Conditions of Approval

Prior to Release Requirements

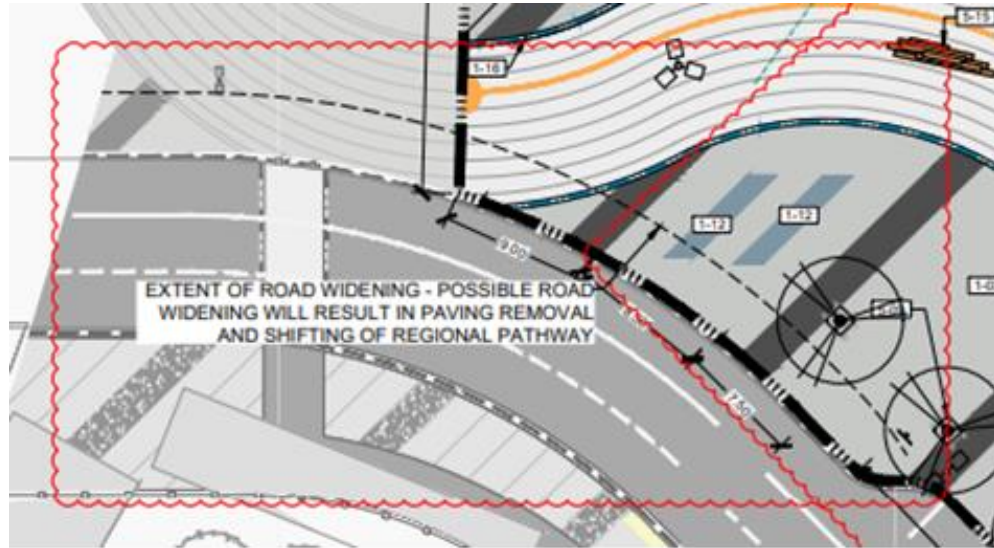
13. Amend the floor plan and all other relevant plans to provide the Class 1 bike storage (including the details of bike rack systems) as discussed as part of the meeting between the City and the Applicant team, incorporating a combination of wall mounted and floor mounted bike storage to the satisfaction of the Director, Transportation Planning.
14. **Prior to Release of the file**, the Applicant is to provide a concept design and shadow plan indicating the ultimate intersection configuration for 17 Avenue/ Macleod Trail Southeast, including the full four-lane approach (i.e. additional Westbound lane on 17 Avenue “upstream”/ East of Macleod Trail) until the four-lane roadway transitions to two lanes.

Provide an overlay of this design on the site plan and/or landscape drawing to illustrate whether modifications to landscaping and walkway areas are needed.

NOTE: The provided overlay is not adequately showing the extent of the future road widening, and possible conflicts with structures and landscaping (See images below). Amend all applicable plans accordingly. The review of the overlay during the prior to release stage of this Application, may require changes to the Site Plan. Amend the Plan accordingly.

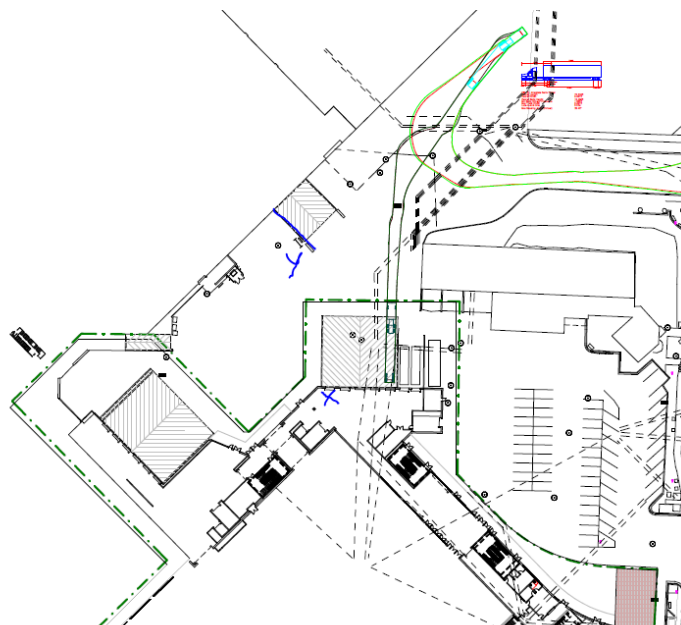
15. **Prior to Release of the file**, the Applicant is to provide an intersection sight distance analysis for the proposed intersection of the two internal roads and the proposed mid-block crossing prepared by a Professional Engineer registered in the Province of Alberta. The Applicant's Engineer is to confirm design parameters with Administration prior to completing the analysis. Amend the Plans accordingly to remove obstructions to sight lines.

The intent of the safety analysis is to ensure that adequate sight distance is provided so that conflicts between pedestrians, cyclists and motor vehicles are mitigated. Visibility is a key consideration when considering the goals of a Vision Zero environment.
